CITY OF HOBART

SPECIAL CITY PLANNING COMMITTEE MEETING

MONDAY, 10 MAY 2021

3.1.1	21B Enterprise Road and 21A Enterprise Road, and 26 Edith Avenue (CT 169835/105) and 35 Enterprise Road, and Adjacent Road Reserve, Sandy Bay - 20 Multiple Dwellings and Associated Works	
A.	Stuart McKenzie-Hall - Deputation Supporting Information - 21B Enterprise Road.....	2
B.	Jocelyn McFie - Deputation Supporting Information - 21B Enterprise Road.....	9
C.	Peter Sibly - Deputation Supporting Information - 21B Enterprise Road.....	14

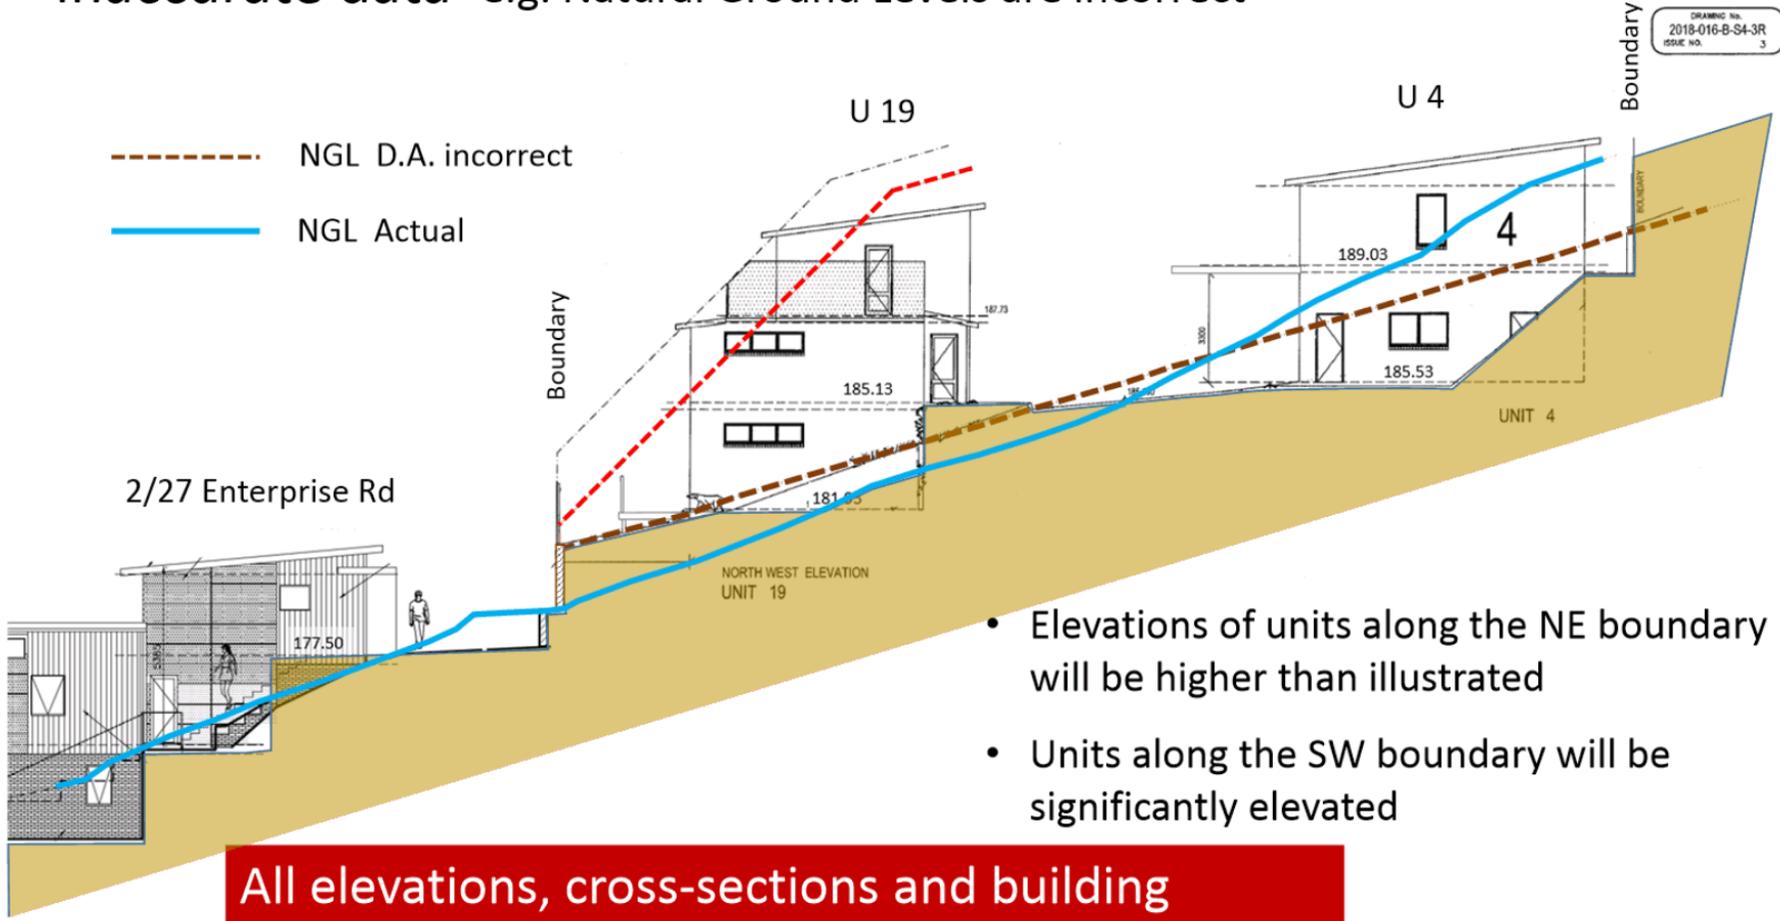
Inaccurate data e.g. Natural Ground Levels are incorrect

- Elevations of units along the NE boundary will be higher than illustrated
- Units along the SW boundary will be significantly elevated

Typical cross-section looking southeast

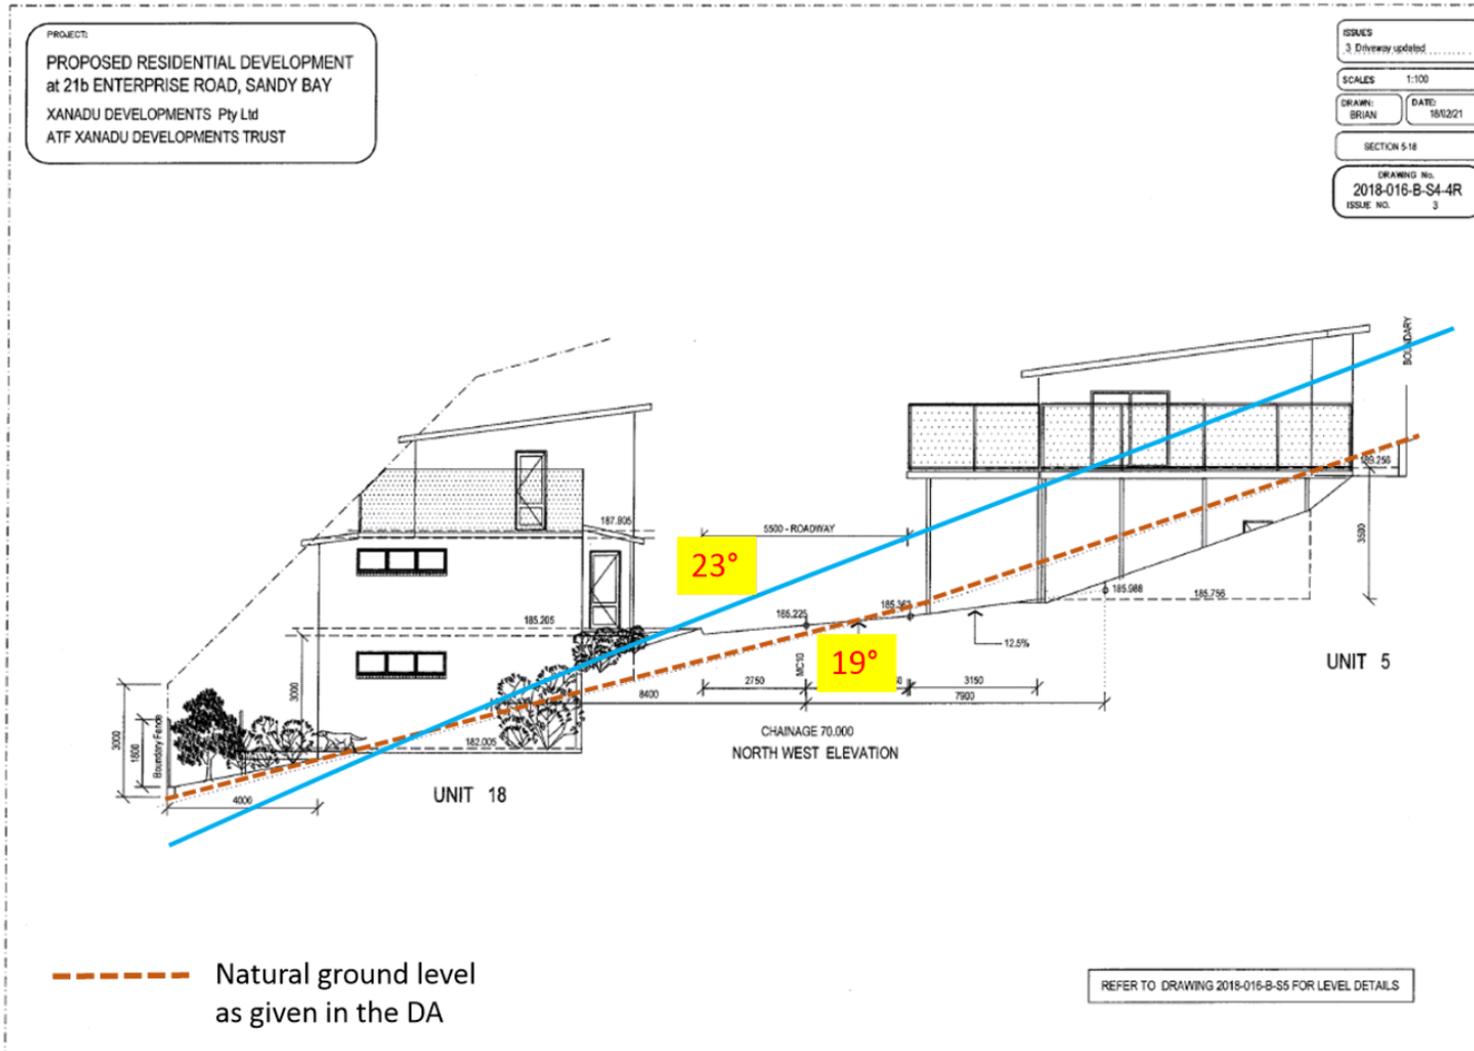
Slope angles are from Council's Geocortex mapping system, referred to in Planner's report, casting doubt on the assessment.

Correct shadow diagram at 1500 hrs on the 21st of June.

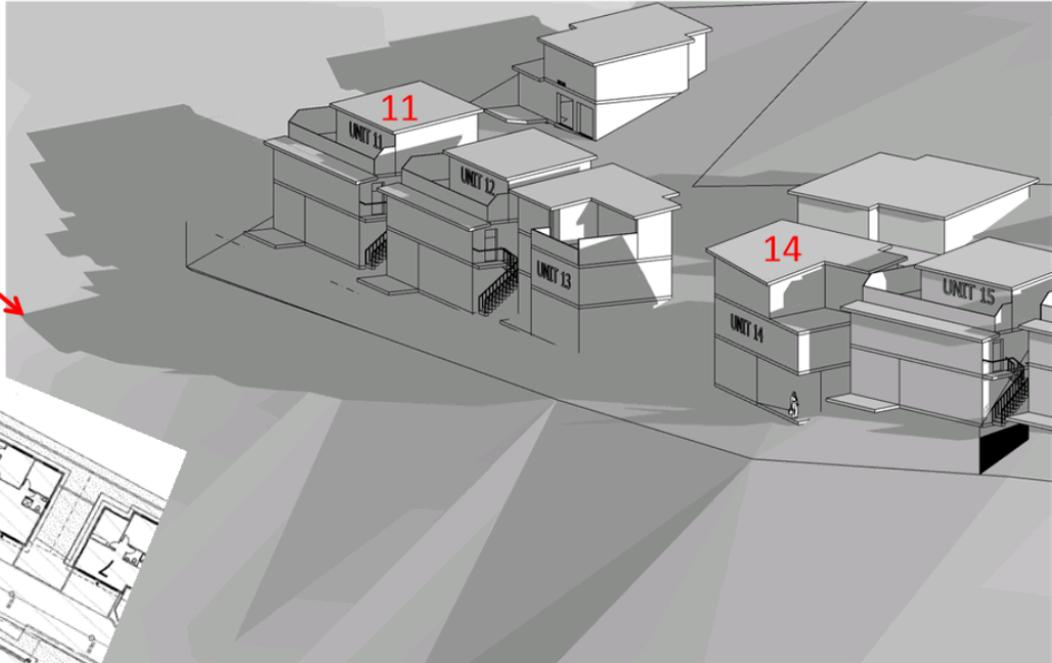
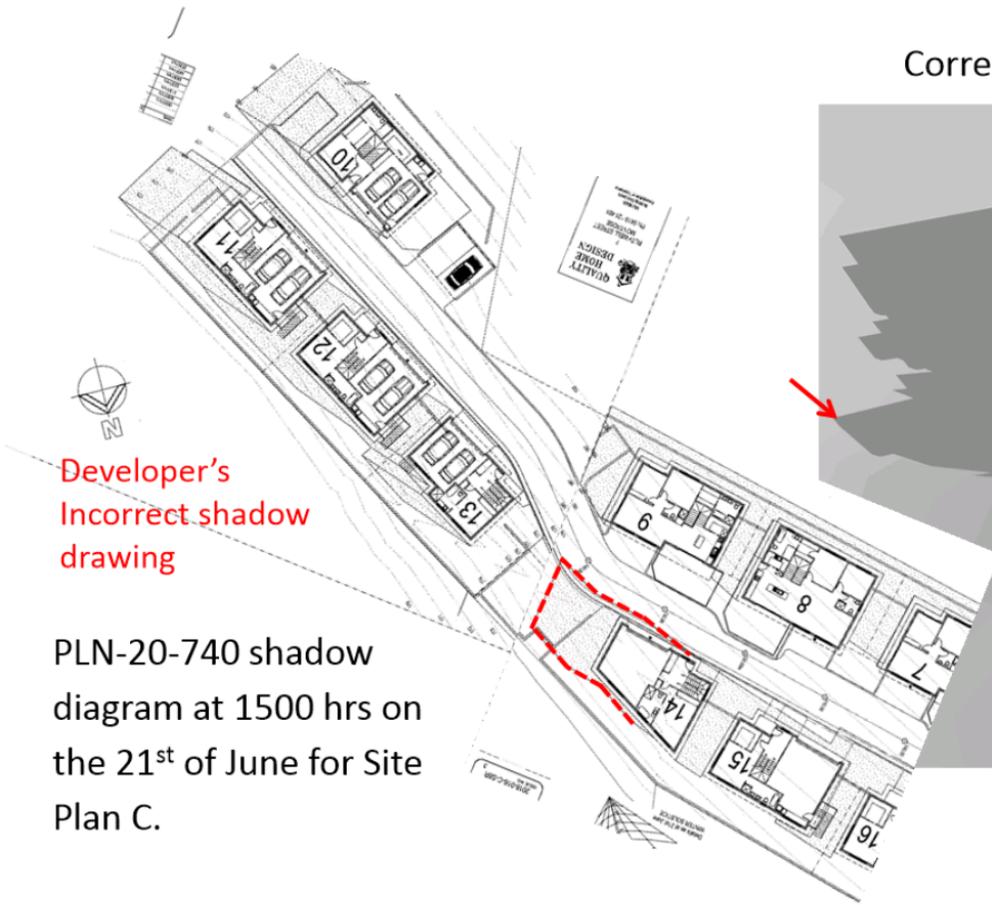
Inaccurate data e.g. Shadow diagrams

All the shadow diagrams provided in PLN-20-740 are inaccurate

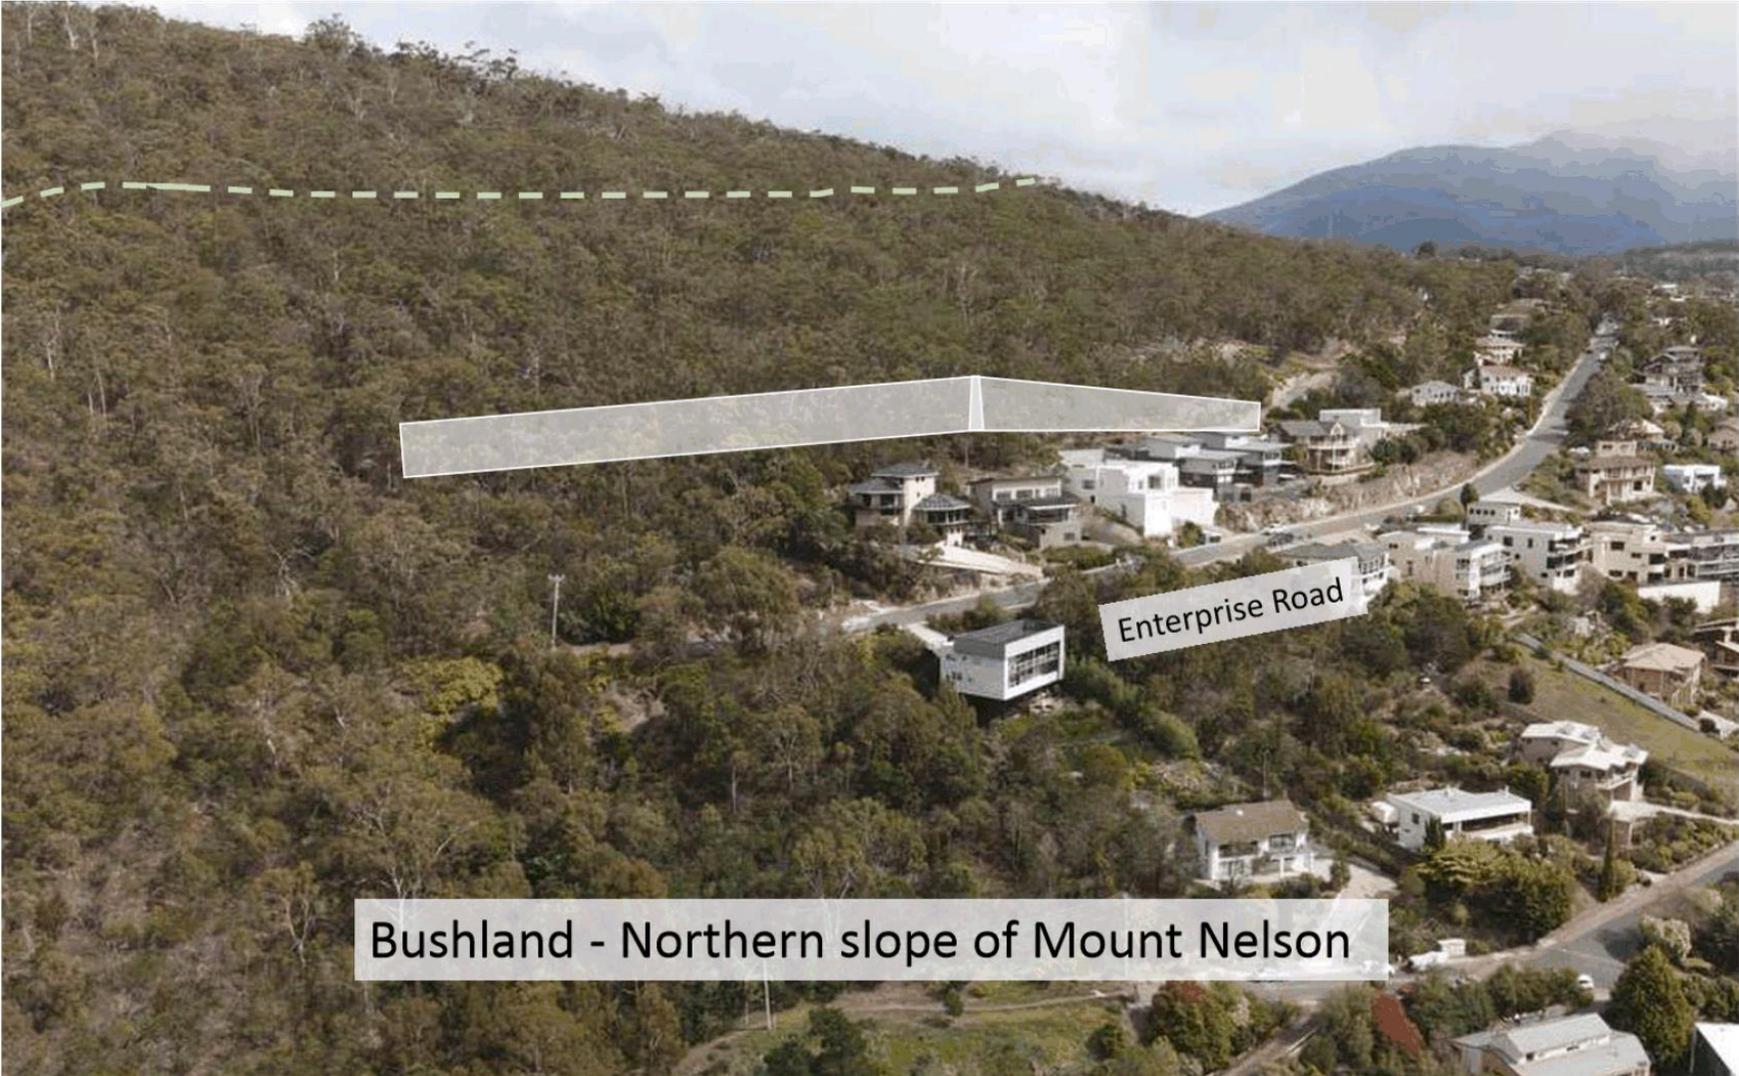
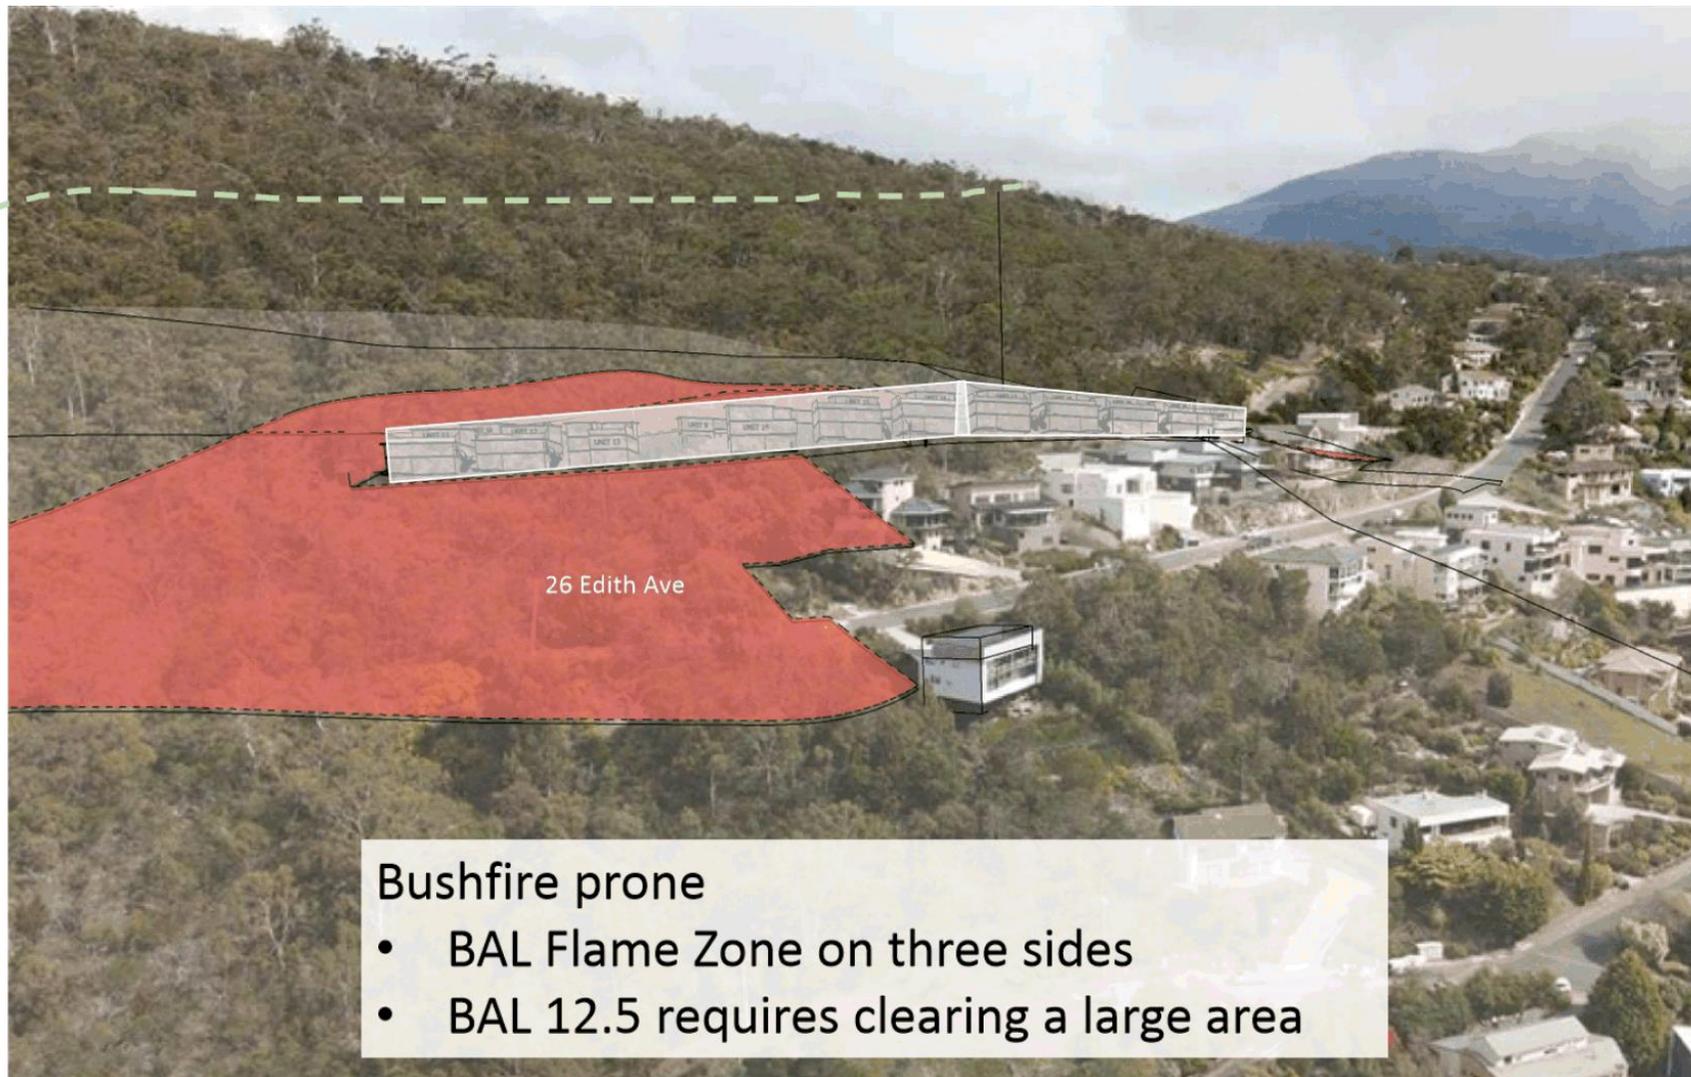
- 6.7.5 As a preliminary matter, there is concern that slope has been underestimated under the submitted plans, resulting in doubt as to the potential compliance of dwellings with the building envelope. The stated slope on submitted plans is of the order of 19 to 20 degrees. The applicant is adamant the plans are accurate. Under Council's Geocortex mapping system, the prevailing slope of the site is of the order of 23 degrees. The potential under-estimate will have implications for the building envelope compliance of all dwellings, and more significantly, the potential impact of the lower row of dwellings, Nos. 11-20.

While there may remain some potential for excavation or other measures to ensure the building envelopes remain as shown, there remains some doubt with regard to assessment. The potential impact of all dwellings is considered below.

PLN-20-740 Natural Values Determination
North Barker 2019, p.8

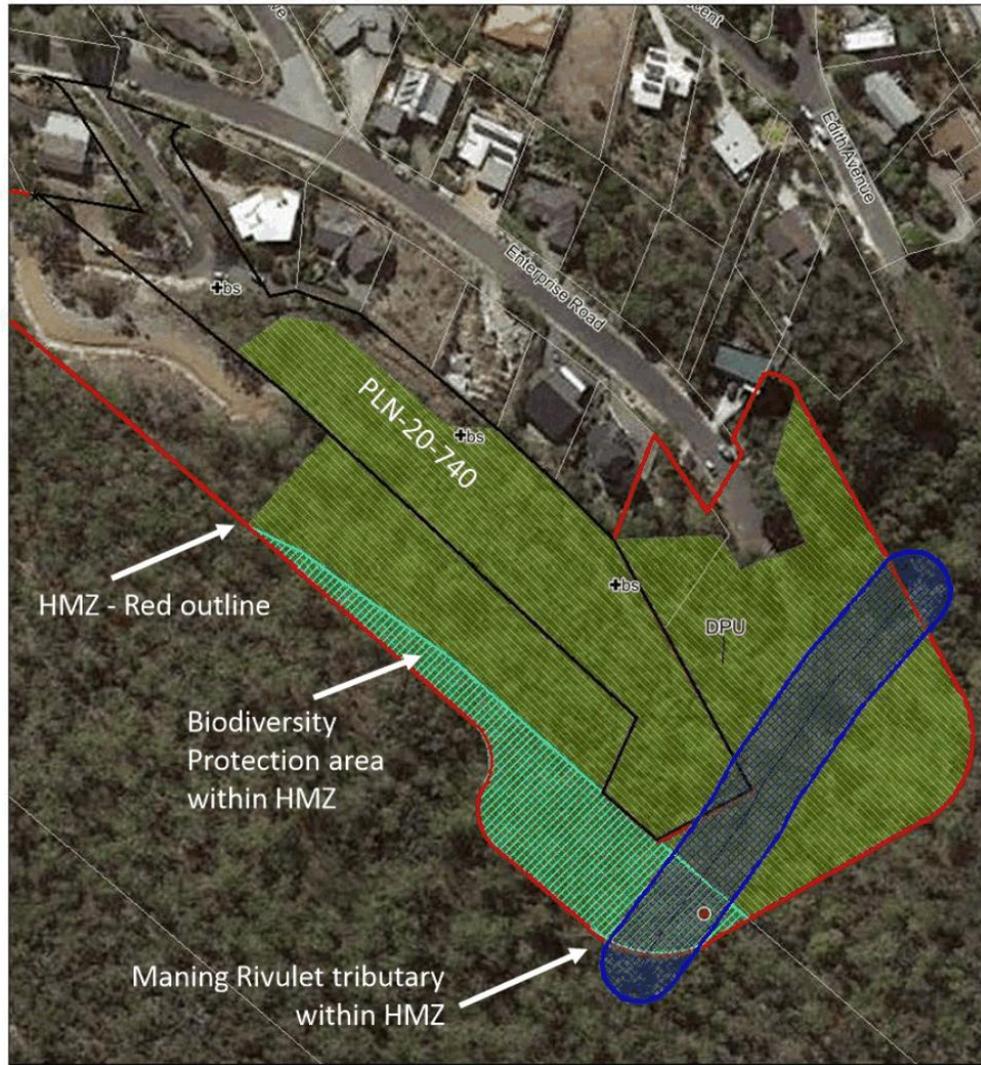
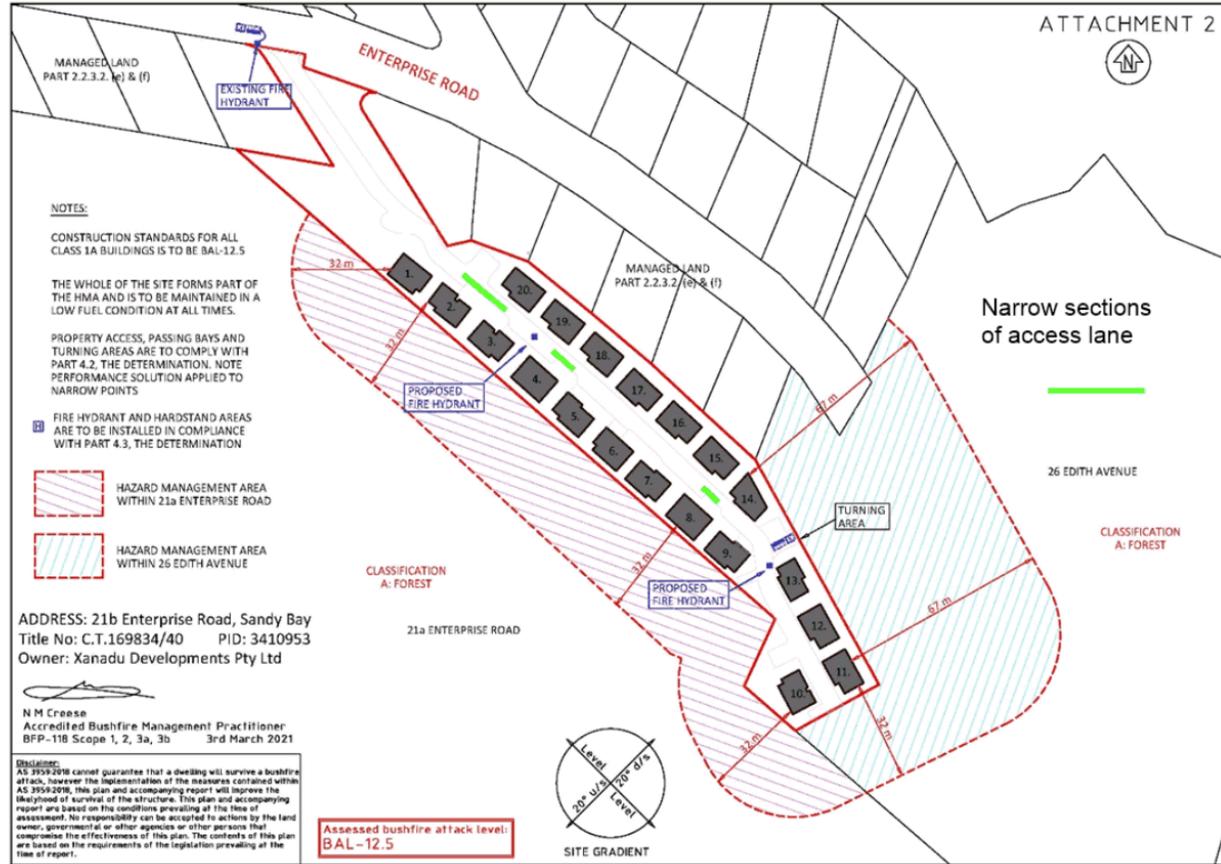
- BAL Flame Zone on three sides
- BAL 12.5 requires clearing a large area

- Impacts have not been **avoided or minimised**
- Does not meet E10.7.1, P1 nor E11.7.1, P1
